May 18, 2010
NOC-AE-10002532
File No.: G25
10 CFR 50.90

South Texas Project
Units 1 and 2
Docket Nos. STN 50-498, STN 50-499
License Amendment Request for
Reactor Coolant System Pressure Transmitter Replacement

Subject: License Amendment Request for Reactor Coolant System Pressure Transmitter Replacement

SCHEMATIC OF TYPICAL RESIDUAL HEAT REMOVAL SYSTEM INLET LINE ISOLATION VALVE ARRANGEMENT

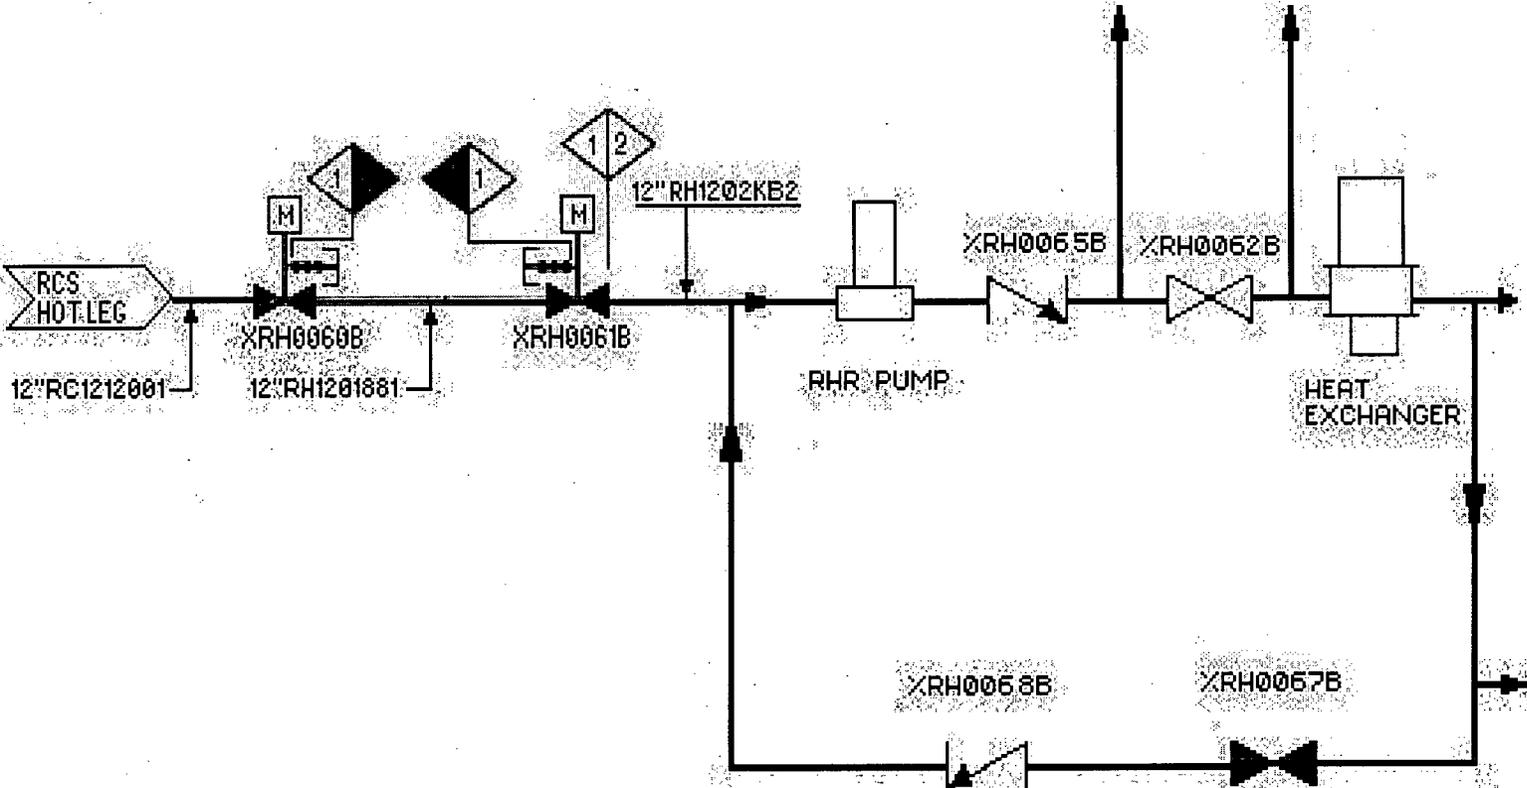
There are three isolation interlock pressure transmitters, and three RHR trains with two isolation valves on each RHR inlet line. Each pressure transmitter controls two RHR inlet line isolation valves (one closer to the RCS, and one closer to the RHR pump), but on different trains. If a pressure transmitter is not functional, a separate transmitter keeps the companion valve closed when RCS pressure exceeds RHR pressure.

A pressure transmitter signal provides a permissive that allows the associated valve to be opened. Without the required signal, the "open" permissive ensures that the valve does not open when the combination of the RCS pressure and the RHR pump discharge pressure exceeds the RHR system design pressure. The two valves in each RHR train receive "open" signals from different pressure transmitters through the Engineered Safety Features (ESF) actuation train.

Using two independently powered motor-operated valves (MOVs) in each of the three inlet lines, along with independent pressure interlock signals for the "prevent-open" function, assures that the design meets applicable single failure criteria. In each RHR subsystem, the interlock signal provided to the isolation valve closest to the RCS is independent and from the interlock signal provided to the isolation valve closest to the RHR. More than one single failure must be postulated to defeat the function preventing exposure of the RHR system to RCS normal operating pressure. The protective interlock design, in combination with plant operating procedures, provides a means of accomplishing the protective function.

The two valves in each RHR system inlet line are powered from different Class IE power sources. Diversity in preventing exposure of the RHR system to the higher RCS pressure is provided by locking out power to the isolation valves in each train at the motor control center when the RHR system is not in service to prevent spurious opening of a valve during plant operation. This power lockout must be disabled before the valves can be opened.
